Adult External-Sealing Enema Nozzle

Design and materials review of specification v0.3

24 July 2026

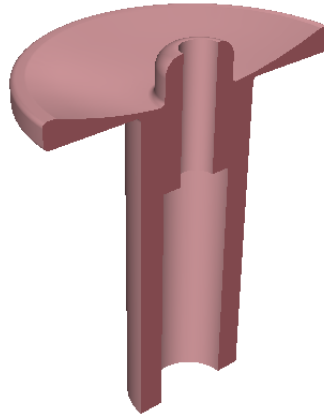
This is the risk I would most want to test early, and it is not addressed in v0.3. The perianal surface is not a plane. It sits within the gluteal cleft. A 4 mm deep dish on a 50 mm circular flange with a 2 mm lip is a relatively stiff, shallow saucer: it will make good contact at the three and nine o’clock positions and bridge at twelve and six, which is where a leak path opens.

1. **Go softer.** Shore A 10 as the baseline. A firmer flange cannot drape into a cleft under gentle hand pressure.
2. **Make the sealing skirt thinner and deeper** rather than a shallow dish, so it conforms instead of spanning.
3. **Consider an oval flange** with its long axis oriented anterior to posterior, along the cleft. This is a single dimension change in the CAD.
4. **Treat the 55 mm variant with caution.** On a stiff flange, more diameter can worsen bridging rather than improve sealing. Diameter and conformity are not the same lever.

P1 shown in section, revealing the internal flow path: the constant-diameter lumen, the step out to the socket bore that grips the handpiece, the internal seating shoulder, and the shallow concave dish with its central nose. The darker faces are the cut plane. The shallowness of the dish relative to the flange width is the conformity concern described above.

The four prototype variants, generated from the accompanying CAD files. P2 carries the wider 55 mm flange; P3 is the flush, fully non-inserting version; P4 has the maximum 5 mm nose projection.

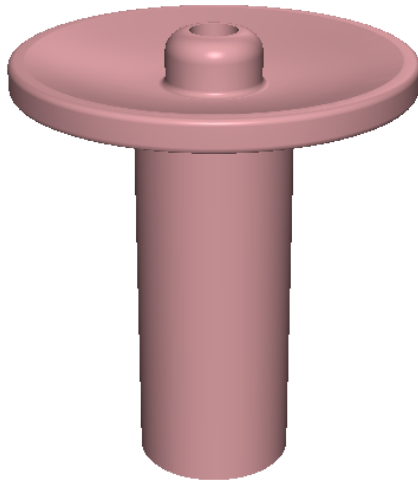
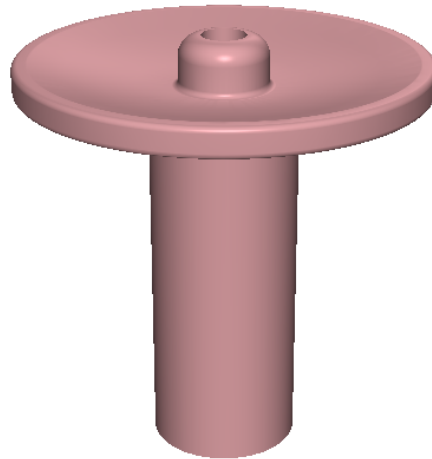
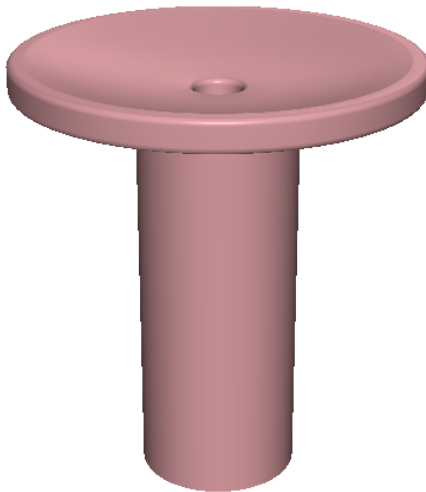
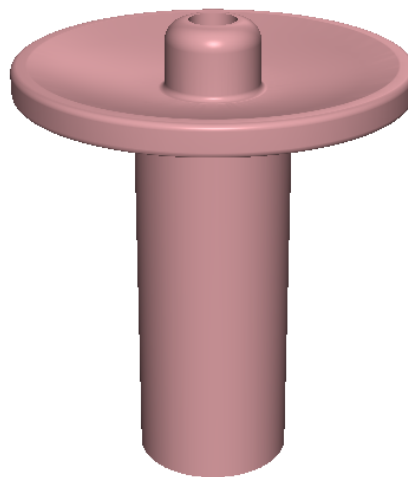
Each file was checked rather than assumed: flange diameter and nose projection are verified against the intended values, the internal flow path is confirmed open from end to end, and the models were rendered and compared against Figure 1 in your specification.

Two points for whoever quotes the work. First, **the socket bore is currently a placeholder**. It cannot be finalised until the steel handpiece spout is measured, which remains the one genuine blocker in the project. Second, these are design-intent models: a production mould additionally needs draft angles, parting-line placement and shrinkage compensation, which the moulder will add in their own CAD. That is normal, and it is what Section 7 of your specification already asks them to supply.
